**METROPOLITAN GOVERNMENT OF NASHVILLE AND DAVIDSON COUNTY**

**STAFF RECOMMENDATION**  
**1302 Shelby Avenue**  
**December 19, 2012**

**Application:** New construction – accessory building; Reduce setbacks  
**District:** Lockeland Springs-East End Neighborhood Conservation Zoning Overlay  
**Council District:** 06  
**Map and Parcel Number:** 08313026500  
**Applicant:** Josh Gipson, All American Garage Builders  
**Project Lead:** Sean Alexander, sean.alexander@nashville.gov

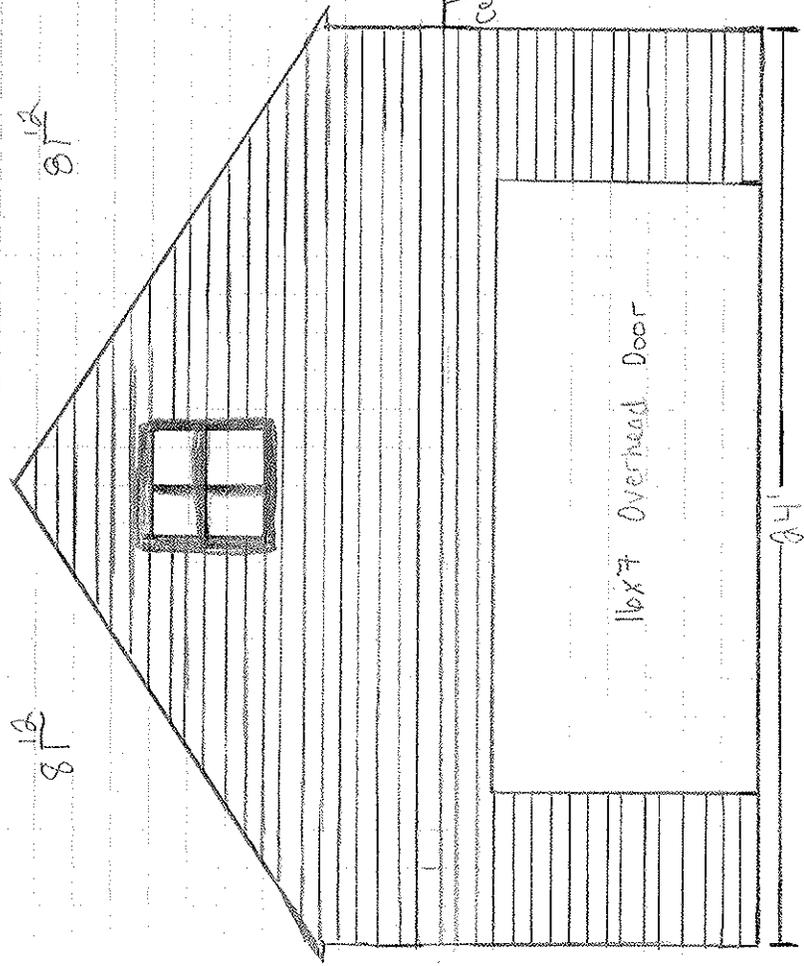
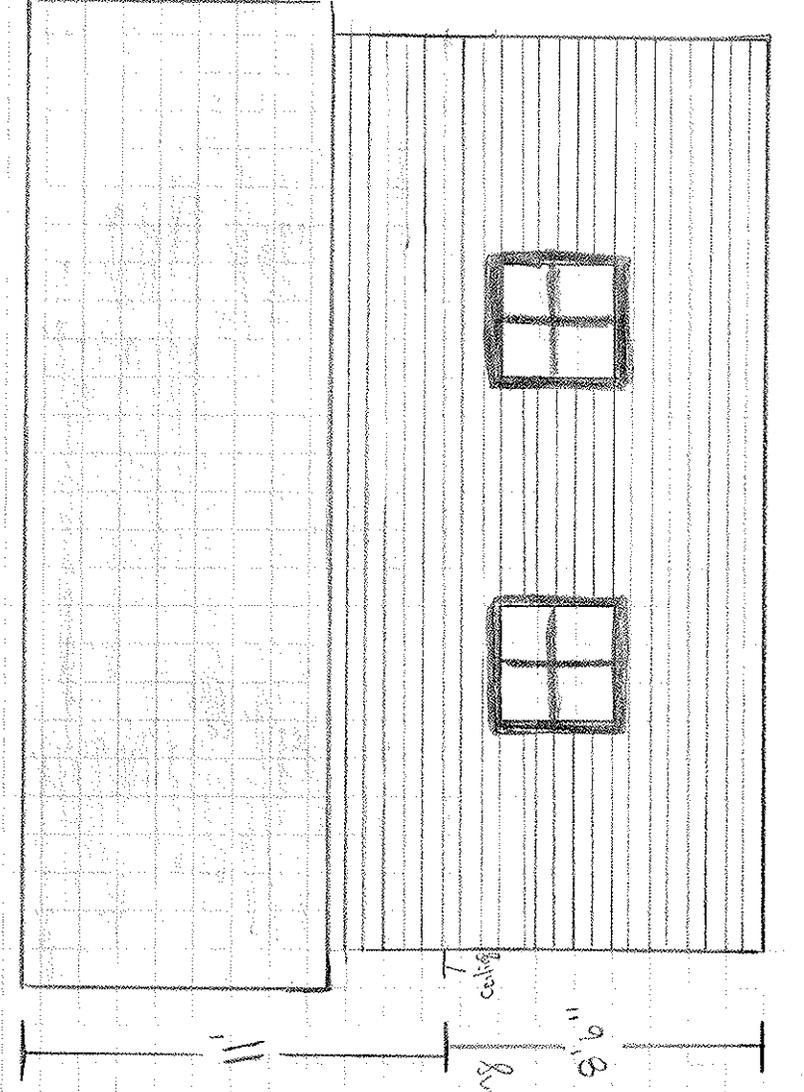
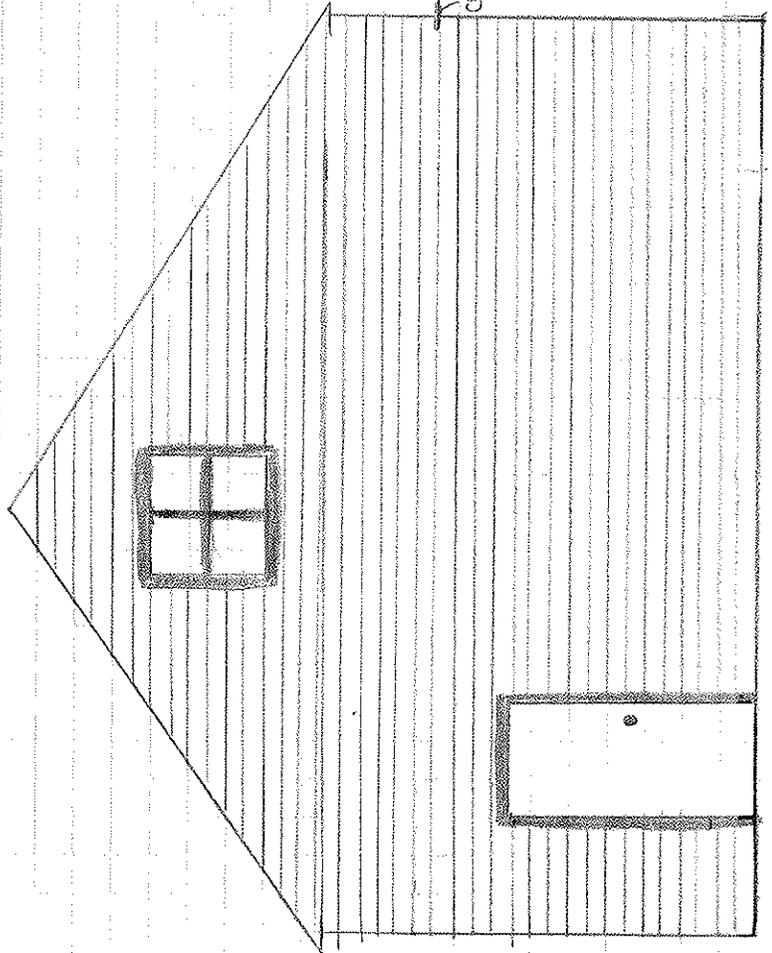
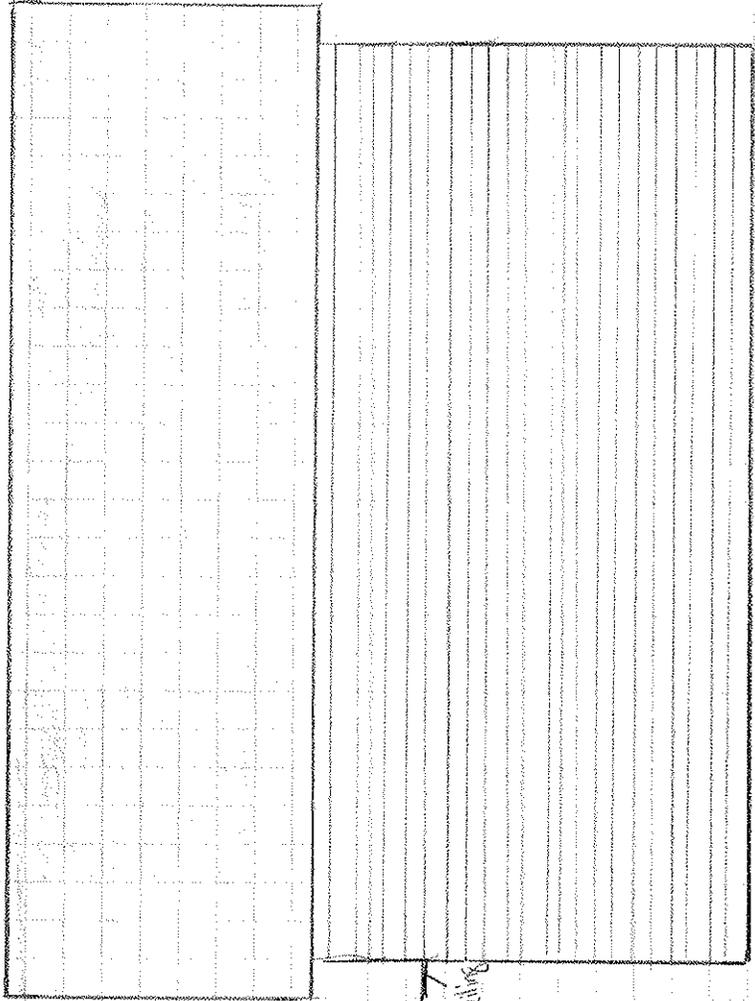
The building will be eighteen feet, six inches (18'-6") tall at the peak, with eaves at eleven feet, six inches (11'-6") above the finished floor level. The roof will be a 4.5:12 pitched gable with a front-rear ridge, a common roof form for accessory buildings. Staff finds these proportions to be compatible with historic accessory structures, and to meet guidelines II.B.1., II.B.2., and II.B.5.

The exterior siding will be smooth-faced cement-fiber siding with a five inch (5") reveal with cement-fiber trim. The roof material will be composite shingles matching the roof of the house, and the foundation will be slab-on-grade. The windows will be wood, but the size and type are not known. The drawings do not show adequate detail about fascia and eave depth, trim proportions, and window size. Because a structure of this size could

typically be approved by staff if there were not a request for reduced setbacks, staff can approve these outstanding issues administratively upon receiving adequate drawings to ensure compliance with guidelines II.B.4. and II.B.7.

Staff recommends approval of the proposed accessory building with a reduced rear setback, with the condition that staff approves specifications of the fascia and eave depth, trim proportions, and window size, to be provided by the applicant before a permit is issued. With that condition, staff finds that the structure would meet the Lockeland Springs-East End Neighborhood Conservation Zoning design guidelines.
